**CITY OF CARPINTERIA
ARCHITECTURAL REVIEW BOARD
Meeting of January 15, 2014**

**COMMUNITY DEVELOPMENT DEPARTMENT
PROJECT REVIEW**

Project: 14-1740-DP/ARB **Planner:** Shanna R. Farley-Judkins
Address: 4879 Dorrance Way
APN: 003-440-021
Zoning: Planned Residential Development (PRD-20)
Applicant: Erik Olson

This is the preliminary review of a request to construct a 2,634 square foot two story single family residence and attached two-car garage. The proposed structure would measure a maximum height of roughly 24 feet nine inches. The proposed unit's habitable space would be 2,199 square feet, with four bedrooms and three bathrooms. The garage would measure 435 square feet and accommodate two parking spaces. The proposed project has a craftsman architectural style.

② SITE PLAN
1/8" = 1'-0"

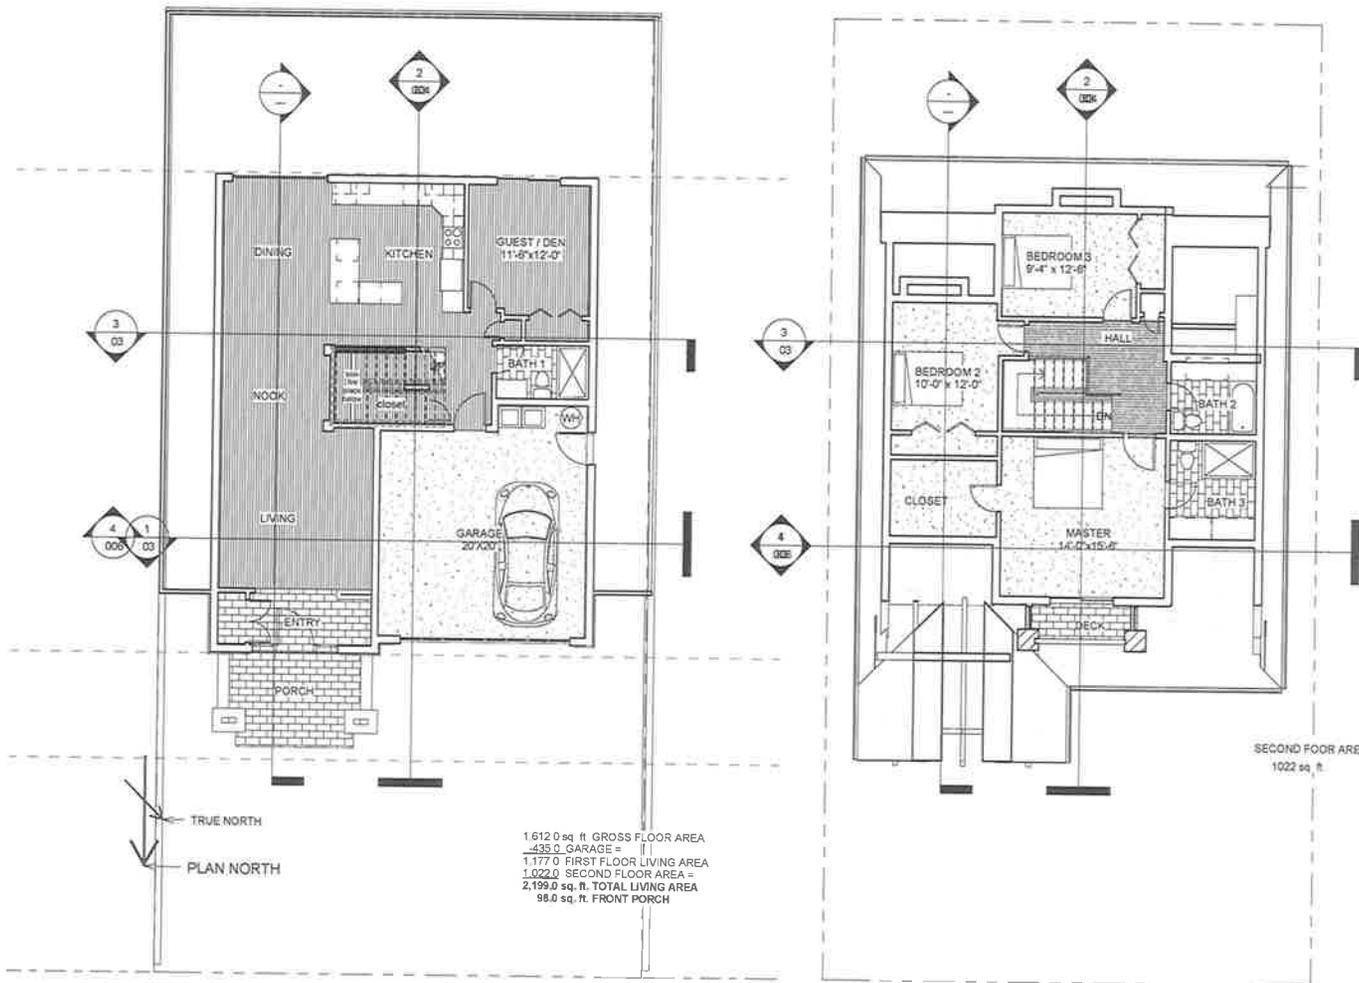
*The porch requires a modification to the front yard setback which encroaches 10 feet into the setback.

The project meets most of the Zoning requirements for the Planned Residential Development Zone District. The majority of the structure meets setback requirements, but the porch facing the front of the lot encroaches into the front setback by ten feet. As outlined in Municipal Code §14.50.120, the application will require a modification to the setback requirement to allow the porch to encroach beyond the front setback. The Board should comment on the location of the porch in consideration of the modification that will be considered. The modification will be reviewed along with the Development Plan for the project which is tentatively scheduled for February 2, 2015.

FIRST & SECOND
 FLOOR PLANS

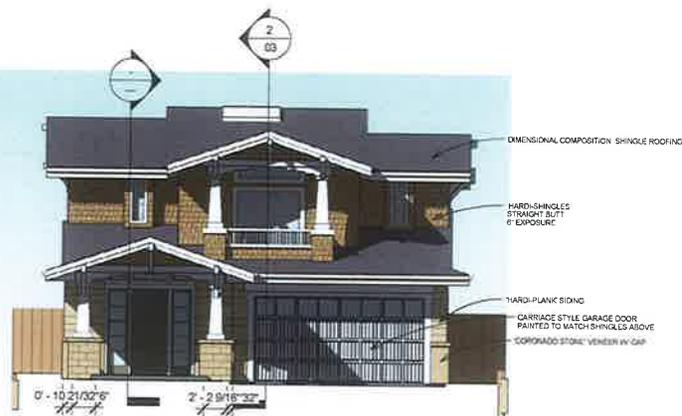
The scale and mass of the home is stacked from the ground floor to the second floor without any breakups. The overall massing of the structure is boxy, only being stepped back along the front

and rear of the home. In general, the second floor should measure less than 40% of the homes total square footage which is analyzed in Design Guideline DG-4. The mass of the second floor comprises 39% of the homes total mass which although complies with Design Guideline DG-4, could be shifted to reduce the mass on the sides of the home, as viewed from the street. **As suggested in the above policies and guidelines, further articulation should be considered on the second floor, especially along the side elevations. The east and west side elevations should consider introduction of breakups or larger detail elements to reduce the mass of the large facades as described above in Design Guideline DG-10.**

The forward face of the second floor is stepped back from the ground level by five feet, although the mass of the second floor is not stepped in from the sides of the home. **The Board should consider further articulation along the sides of the second floor to reduce the mass as viewed from the street.**

BUILDING
ELEVATIONS

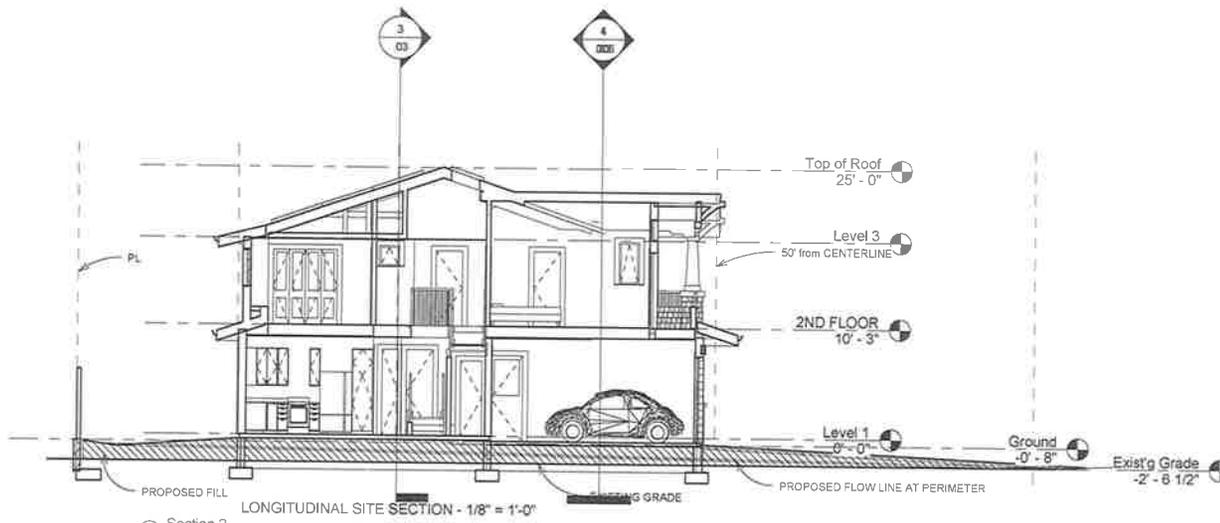
The garage placement is a prominent element along the frontage of the home. The garage and main face of the home are broken up by the projection of the front porch which stands forward of the face of the building. The proposed garage door measures 44% of the total of the home's frontage. The garage design could include additional design elements such as separate doors or a trellis element to help integrate the garage into the overall design of the home as suggested by Design Guideline DG-18. **The Board should consider the prominence of the garage in the overall design of the home.**
